Project	IEEE 802.16 Broadband Wireless Access Working Group < http://ieee802.org/16 >	
Title	Idle Mode – Location Update Enhancement	
Date Submitted	2004-11-05	
Source(s)	Ronny (Yong-Ho) Kim, and Changjae Lee LG Electronics, Inc. 533, Hogye-1dong, Dongan-gu, Anyang-shi, Kyongki-do, Korea	Voice: +82-31-450-2945 Fax: +82-31-450-7912 mailto: [ronnykim, cjlee16]@lge.com
Re:	Response to Sponsor Ballot	
Abstract	Idle Mode – Location Update Enhancement in 802.16e	
Purpose	Adoption of proposed changes into P802.16e	
Notice	This document has been prepared to assist IEEE 802.16. It is offered as a basis for discussion and is not binding on the contributing individual(s) or organization(s). The material in this document is subject to change in form and content after further study. The contributor(s) reserve(s) the right to add, amend or withdraw material contained herein.	
Release	The contributor grants a free, irrevocable license to the IEEE to incorporate material contained in this contribution, and any modifications thereof, in the creation of an IEEE Standards publication; to copyright in the IEEE's name any IEEE Standards publication even though it may include portions of this contributi

Figure 1. Idle Mode Location Update – Power Down

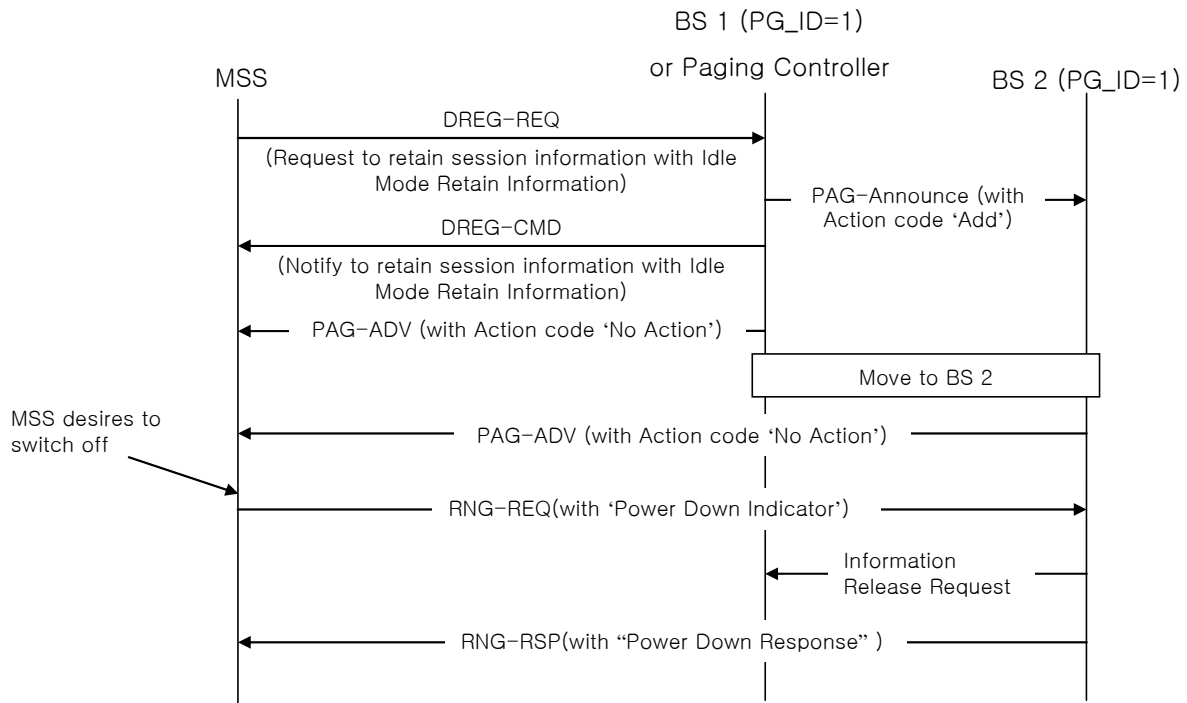
In this contribution, Idle Mode location update enhancement is proposed. When an MSS goes into Idle Mode there is information retained and used for expedited network entry from Idle Mode. Even though an MSS turns off its power while it is in Idle Mode, Idle Mode Retain information would be maintained until BS finds out the MSS is not available anymore. If an MSS can report its status of power off before an MSS turns off its power, information related to the MSS in Idle Mode can be managed more efficiently. Operation is shown below in Fig. 1. This mechanism enables the Paging Controller to detect unavailability without performing unavailability check through repeated unanswered paging messages or through expiration of the Idle Mode System Timer. Benefit of proposed Location Update enhancement is exact and quick status update of MSS in Idle Mode and unnecessary action reduction to detect MSS's unavailability.

6.3.21.9.1.3 Power Down Update

The MSS shall perform Location Update process prior to switching off its power. This mechanism enables the Paging Controller to update MSS's exact status and to delete all information for the MSS and discontinue Idle Mode Paging Control for the MSS at the time of power down.
